***INTERNATIONAL PHYSICAL PROTECTION  
ADVISORY SERVICE (IPPAS)***

***Mission Report: Japan***

*16–27 February 2015*

*Prepared for the Nuclear Regulation Authority (NRA) of Japan*

Figure 36. Basic protection strategy.

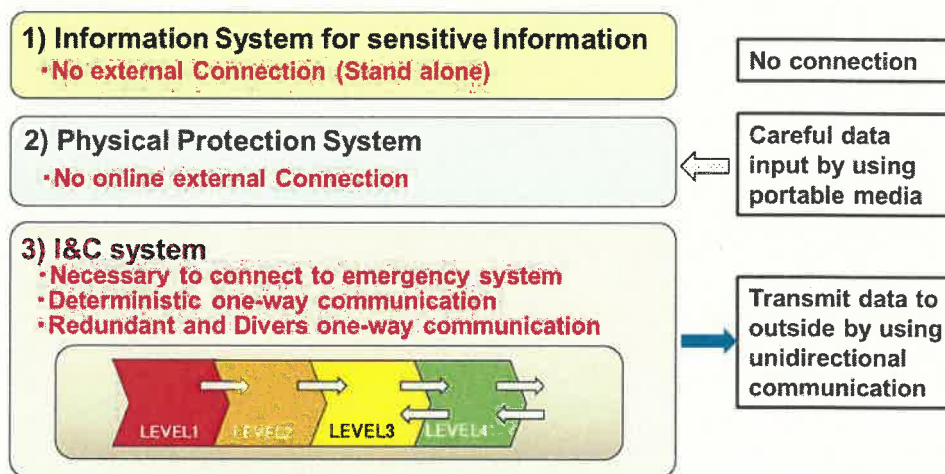
The NRA's authorization for the security plans is required, so the NRA has established a basis for computer security at the facility level (Fig. 36).

**Recommendation:** The NRA should consider further strengthening its ability to effectively inspect computer security at nuclear facilities with dedicated computer security experts. The additional resources (either internal or external) should have in-depth and detailed insight in the highly technical and dynamic area of computer security.

**Suggestion:** The NRA may consider increasing its capability to conduct frequent and comprehensive computer security inspections.

**Figure 37. Inclusion of cyber skills in State DBT.**

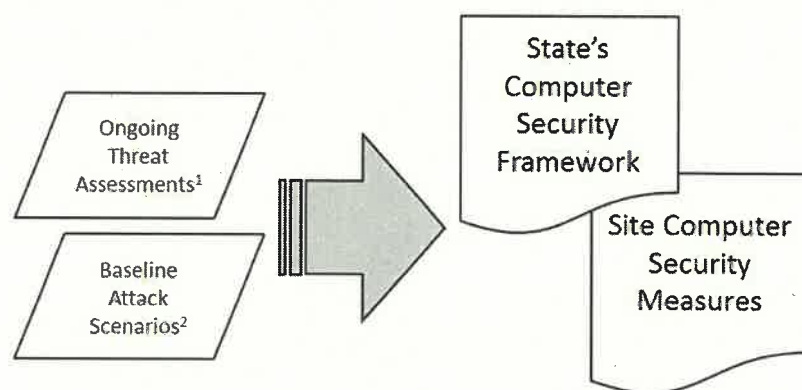
Next, it is also important to develop a longer term view on cyber related threats and risks (Fig. 37). Here, the description of threat needs to be more abstract, not describing actual discovered attack malware but rather describing conceivable adversary scenarios and attack routes and possibly additional cyber-related protection targets that become relevant because of the increase in use of computer systems supporting, for instance, the nuclear safety systems and the physical protection systems.
